The Commission has issued the enclosed Amendment No. 8 to Facility Operating License No. NPF-2 for the Farley Nuclear Plant, Unit No. 1. The amendment consists of changes to the Technical Specifications in response to your applications dated November 4 and December 14, 1977 and August 9, 1978.

JOSEPH M. FARLEY NUCLEAR PLANT, UNIT 1

AMENDMENT TO FACILITY OPERATING LICENSE

Amendment No. 8
License No. NPF-2

Figure 3.2-3 Rod Bow Penalty (RBP)

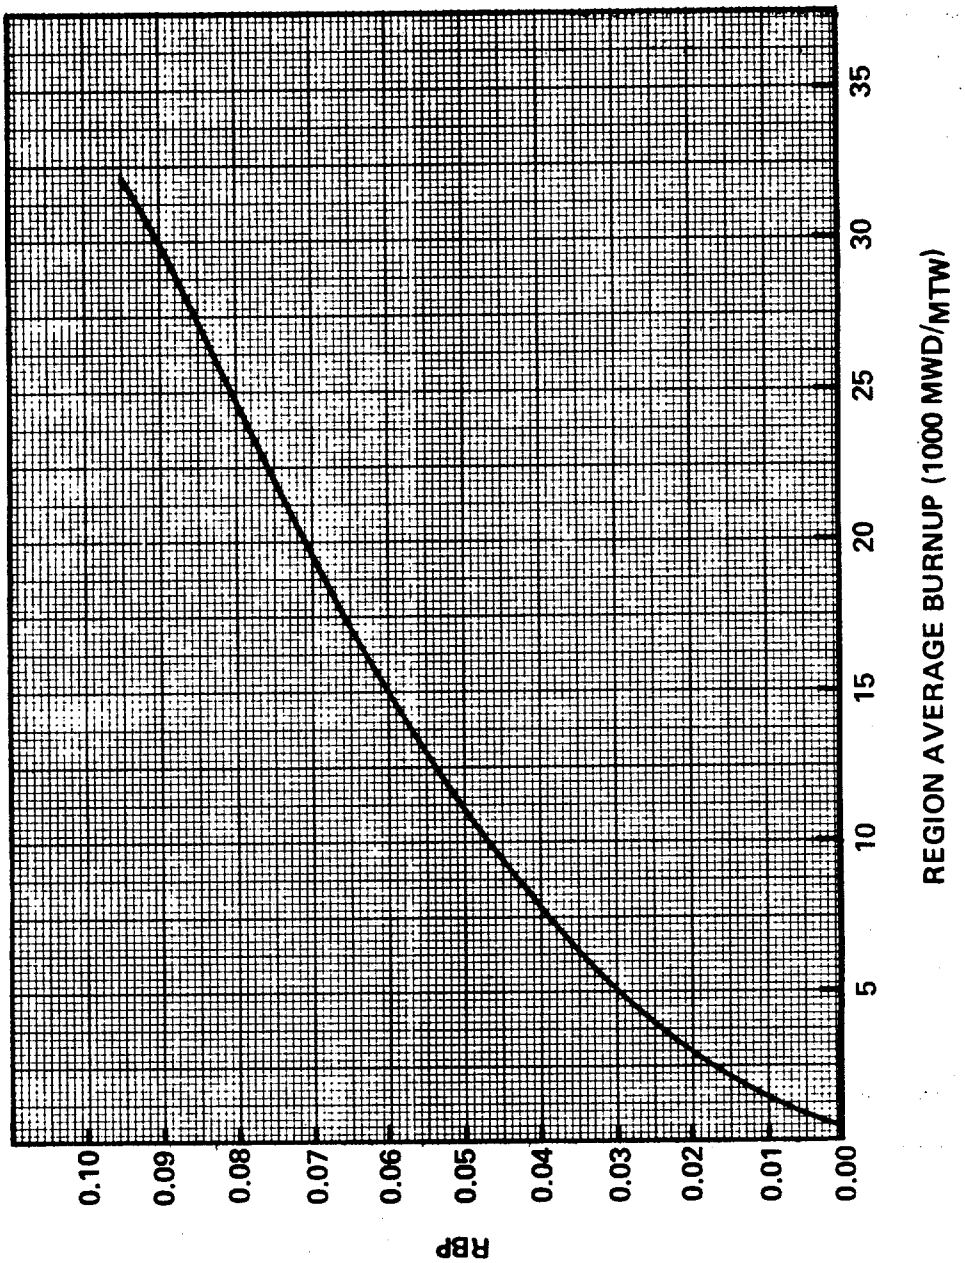
1. Modification to Specification Figure 3.2-3 and Bases 2.1.1 relating to the fuel rod bow penalty for 17x17 fuel designed by Westinghouse.

Figure 3.2-3. The existing figure was derived based on a conservative extrapolation of 15x15 fuel data rather than data for the 17x17 fuel existing in the FNP core.

APC proposed a new equation (see Bases 2.1.1) derived by Westinghouse for predicting the amount of rod bow in 17x17 fuel. This new equation is developed from rod bow data from 17x17 lead test assemblies irradiated in the Surry Nuclear Plant Unit No. 1 and Unit No. 2 reactors. The staff has previously accepted this model for the Trojan reactor[4].

Based on our review of the APC proposal and on the previous evaluation done during the Trojan Nuclear Plant Amendment No. 30 review, we agree the changes are also acceptable for the FNP reactor since it gives a sufficiently conservative estimate of the DNBR reduction.
